Service Bulletin

No. : MZ09-003 **Date:** February 5, 2009

Model: SR4001, SR4002, SR4003, SR5001, SR5002, CD5003

Subject: Correction of the Service Manual, electrical parts list.

REGULATOR PWB of SR4001, SR4002, SR4003, SR5001, SR5002

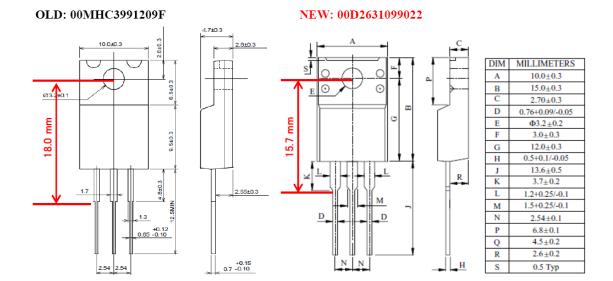
Symptom: The REGULATOR (IC) part number mentioned on the Service

Manual is not correct.

OLD NEW	POS. NO.	VERS. COLOR	PART NO. (MZ)	PART NAME	DESCRIPTION
OLD	IC87		00MHC3991209F	IC	KIA7912PI Factory cord: HVIKIA7912PI
NEW	IC87		00D2631099022	IC	KIA7912PI-U/P Factory cord: HVIKIA7912PI

The difference of package dimensions between 00MHC3991209F and 00D2631099022.

Solution: Service manual correction.
